The Commission has issued the enclosed Amendments Nos. 155, 155 and 152 to Facility Operating Licenses Nos. DPR-38, DPR-47 and DPR-55 for the Oconee Nuclear Station, Units Nos. 1, 2 and 3. These amendments consist of changes to the Station's common Technical Specifications (TSs) in response to your request dated December 12, 1986, as revised on January 29, 1987, and supplemented on February 11, 1987.

OCONEE NUCLEAR STATION, UNIT NO. 1

SAFETY EVALUATION BY THE OFFICE OF NUCLEAR REACTOR REGULATION

OCONEE NUCLEAR STATION, UNITS NOS. 1, 2 AND 3

OPERATIONAL POWER  
 IMBALANCE ENVELOPE  
 FROM 0 FFPD TO EOC UNIT 1  
 BCONEE NUCLEAR STATION

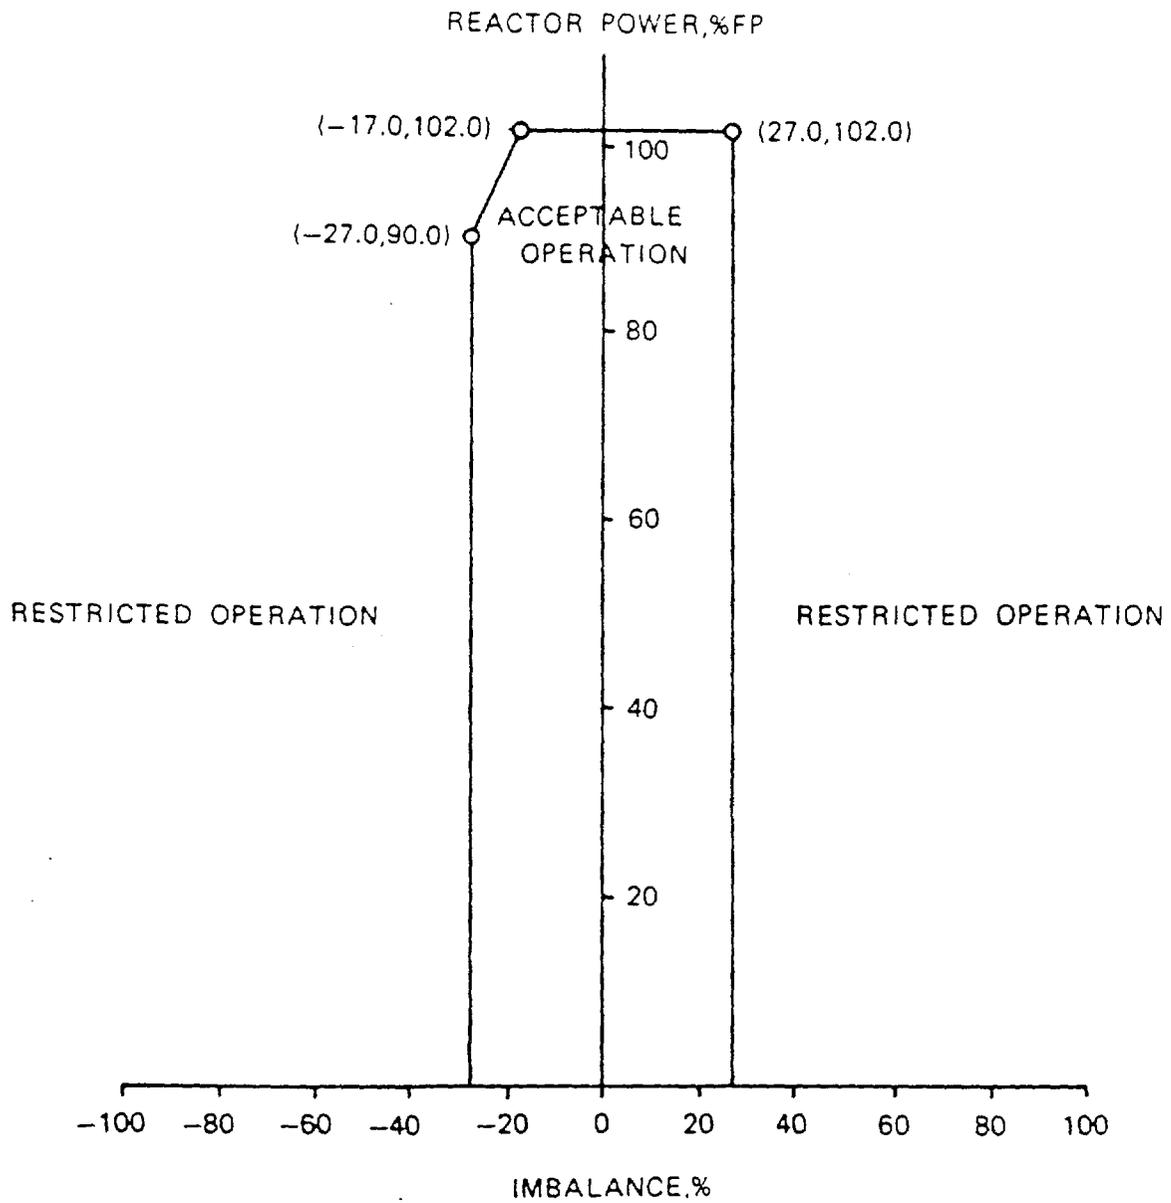
These amendments would also provide a more conservative curve for Oconee Unit 1 Operational Power Imbalance Envelope (Figure 3.5.2-10) to allow 10 CFR Part 50.59 reviews of future core reloads; update TS 3.5.2.4.b.2 (quadrant power tilt) to reflect the fact that power level cutoffs (other than 100%) are no longer applicable to Oconee; delete TS 3.5.2.6 (xenon reactivity) because operating restrictions resulting from transient xenon power peaking are implicitly included in the limits of TS 3.5.2.5 (control rod positions) and proposed TS 3.5.2.6 (reactor power imbalance) and note this in the bases of TS 3.5; and change TSs 3.5.2.7, 3.5.2.8 and 3.5.2.9 to reflect the deletion of TS 3.5.2.6 (xenon reactivity).

OPERATIONAL POWER  
 IMBALANCE ENVELOPE  
 FROM 0 EFPD TO EOC UNIT 3  
 OCONEE NUCLEAR STATION  
 Figure 3.5.2-12

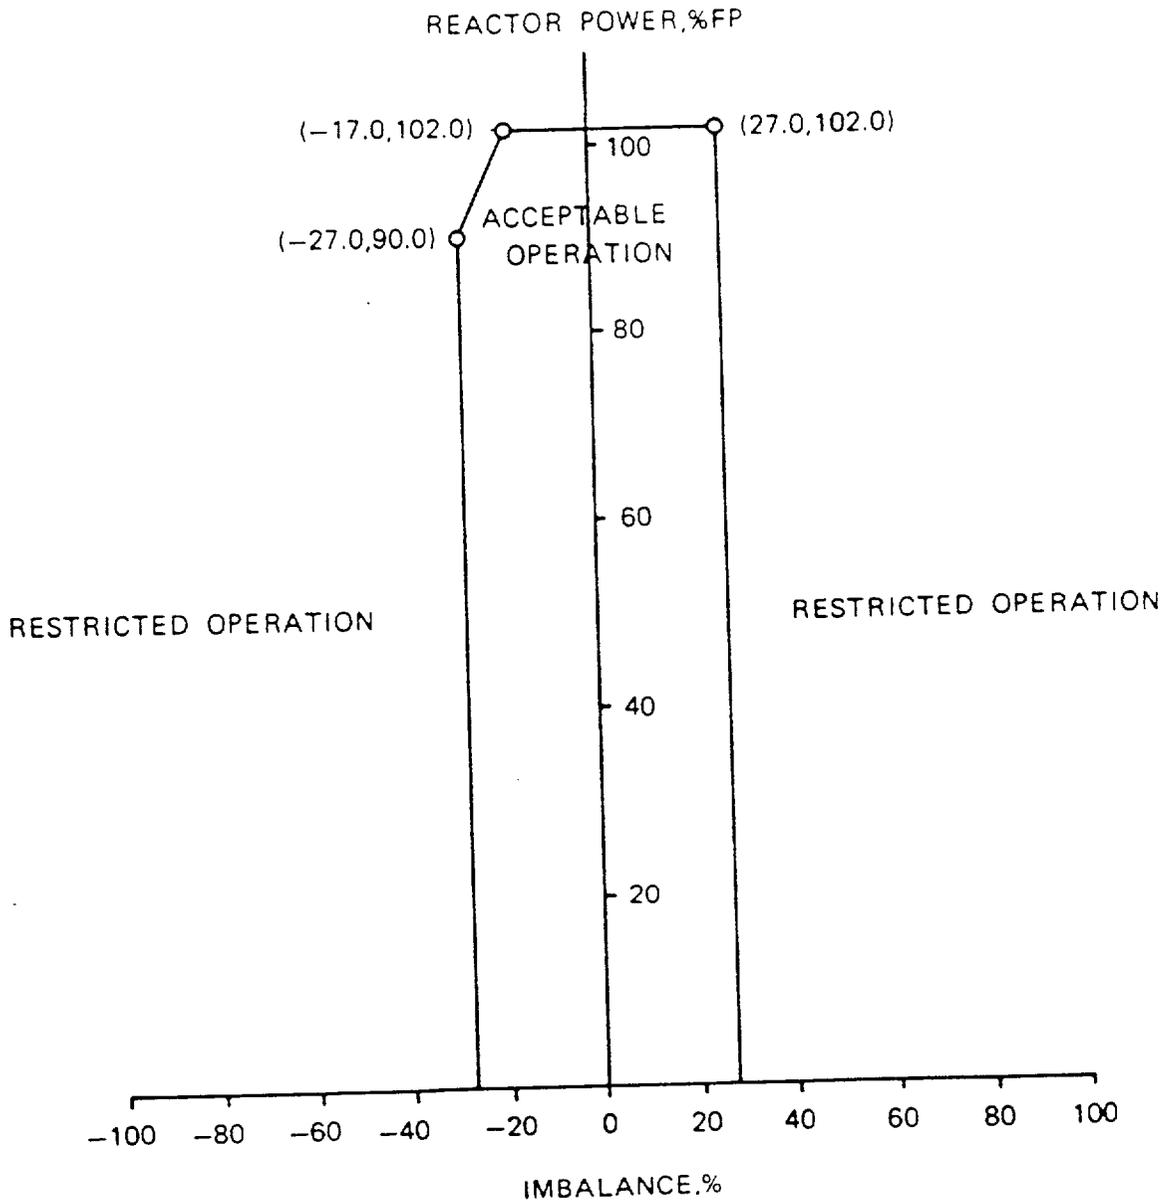
These amendments would authorize changes to the Oconee Nuclear Station TSs which are required to support the operation of Oconee Unit 3 at full rated power during the upcoming Cycle 10. The amendments would change Figure 3.5.2-12, the Unit 3 Operational Power Imbalance Envelope curve. The Figure would be updated to reflect current cycle operating characteristics.

Oconee Unit 3 Cycle 10 TSs have been modified to account for normal cycle-to-cycle fuel changes in power peaking and control rod worths. We have reviewed the proposed specification revisions for Cycle 10. These changes concern the Operational Power Imbalance Envelope (Figure 3.5.2-12). In addition, the licensee has provided a more conservative curve for the Unit 1 Operational Power Imbalance Envelope (Figure 3.5.2-10) in order to reduce future TS changes and to allow more of their future reload cores to be reviewed under 10 CFR 50.59. On the basis that approved methodology was used to obtain these limits which assure that general design criteria 10 and 12 are satisfied, we find these TS modifications acceptable.
